Action Required

Replace the (120V fuse) circuit breaker label and the 12V fuse label

2015 Launch Ultra Lite Travel Trailers

120 Volt label

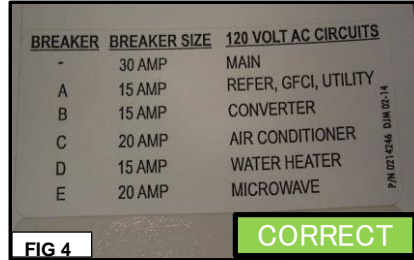
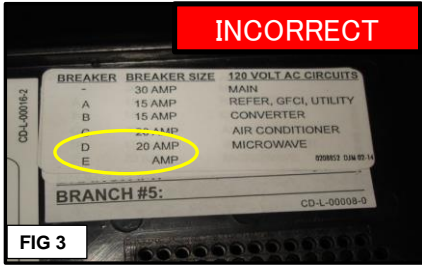
- Fig 3:** Incorrect label shows a 20 Amp for breaker D, and no value for breaker E.
- Fig 4:** Correct label shows breaker D as a 15 Amp for Water Heater, and breaker E as a 20 Amp for Microwave.
- NOTE:** Clean the area with Isopropyl alcohol and allow to dry prior to installing the new label.
- Fig 5:** Cover the old label with the new replacement label.

12 Volt label

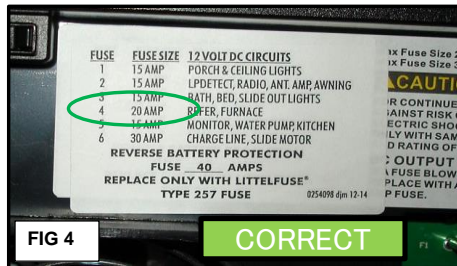
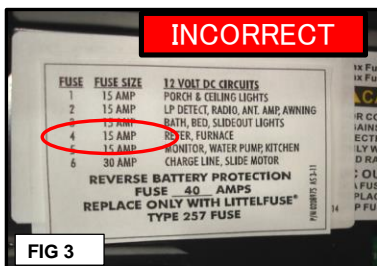
- Fig 3:** Incorrect label shows a 15 amp fuse in position 4 for the refrigerator and furnace.
- Fig 4:** Correct label shows a 20 amp fuse for position 4 for the refrigerator and furnace.
- NOTE:** Clean the area with Isopropyl alcohol and allow to dry prior to installing the new label.
- Fig 5:** Cover the old label with the new replacement label.
